WELL API NO. 30-025-05284
5. Indicate Type of Lease STATE ☐ FEE ☒
6. State Oil & Gas Lease No.
7. Lease Name or Unit Agreement Name J.M. Denton
8. Well Number #10
9. OGRID Number 240974
10. Pool name or Wildcat Denton (Wolfcamp)
11. Elevation (Show whether DR, RKB, RT, GR, etc.) 3798' GR

SUNDRY NOTICES AND REPORTS ON WELLS (DO NOT USE THIS FORM FOR PROPOSALS TO DRILL OR TO DEEPEN OR PLUG BACK TO A DIFFERENT RESERVOIR. USE "APPLICATION FOR PERMIT" (FORM C-101) FOR SUCH PROPOSALS.)	
1. Type of Well: Oil Well ☒ Gas Well ☐ Other ☐	
2. Name of Operator Legacy Reserves Operating LP	
3. Address of Operator P.O. Box 10848, Midland, TX 79702	
4. Well Location Unit Letter L : 2080 feet from the S line and 890 feet from the W line Section 11 Township 15S Range 37E NMPM County Lea	
11. Elevation (Show whether DR, RKB, RT, GR, etc.) 3798' GR

Operator: LEGACY RESERVES OPERATING, LP 15 Smith Road Midland, TX 79705	OGRID: 240974
	Action Number: 87194
	Action Type: [C-103] NOI Plug & Abandon (C-103F)

Legacy Reserves		PROPOSED	
Author:	Abby BCM	Well No.	#10
Well Name	J.M. Denton	API #:	30-025-05284
Field/Pool	Denton (Wolfcamp)	Location:	Sec 11, T15S, R37E
County	Lea		2080 FSL & 890 FWL
State	NM	GL:	3798
Spud Date	3/14/1953

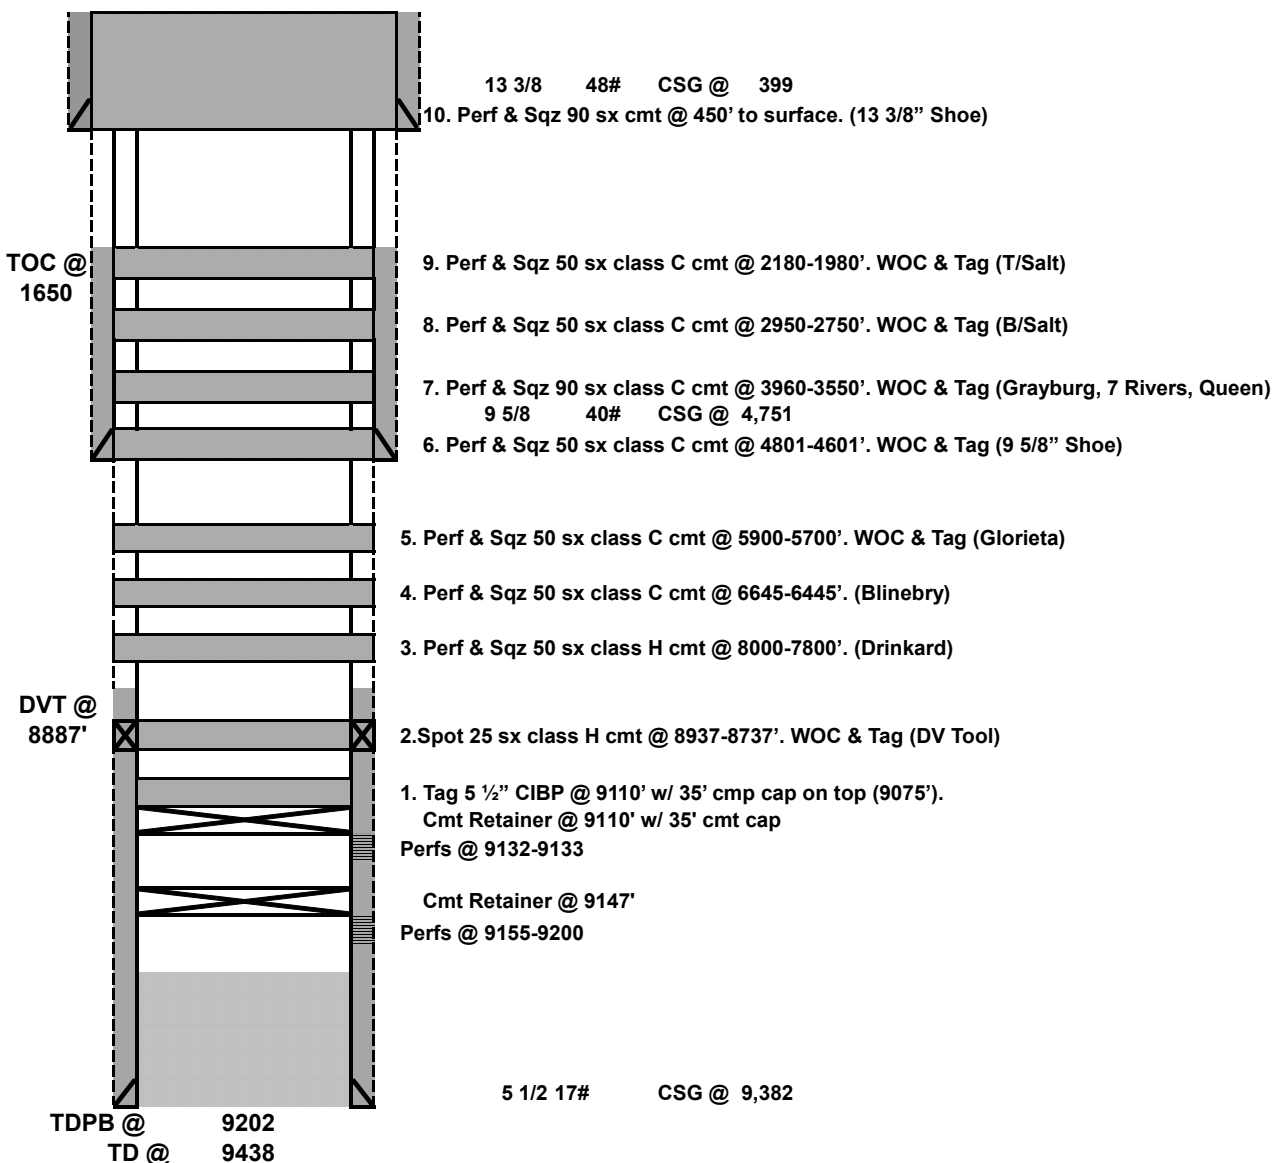
1. Tag 5 1/2" CIBP @ 9110' w/ 35' cmp cap on top (9075').
2. Spot 25 sx class H cmt @ 8937-8737'. WOC & Tag (DV Tool)
3. Perf & Sqz 50 sx class H cmt @ 8000-7800'. (Drinkard)
4. Perf & Sqz 50 sx class C cmt @ 6645-6445'. (Blinebry)
5. Perf & Sqz 50 sx class C cmt @ 5900-5700'. WOC & Tag (Glorieta)
6. Perf & Sqz 50 sx class C cmt @ 4801-4601'. WOC & Tag (9 5/8" Shoe)
7. Perf & Sqz 90 sx class C cmt @ 3960-3550'. WOC & Tag (Grayburg, 7 Rivers, Queen)
8. Perf & Sqz 50 sx class C cmt @ 2950-2750'. WOC & Tag (B/Salt)
9. Perf & Sqz 50 sx class C cmt @ 2180-1980'. WOC & Tag (T/Salt)
10. Perf & Sqz 90 sx cmt @ 450' to surface. (13 3/8" Shoe)
11. Cut off well head, verify cmt @ surface, weld on Above Ground Dry Hole Marker.
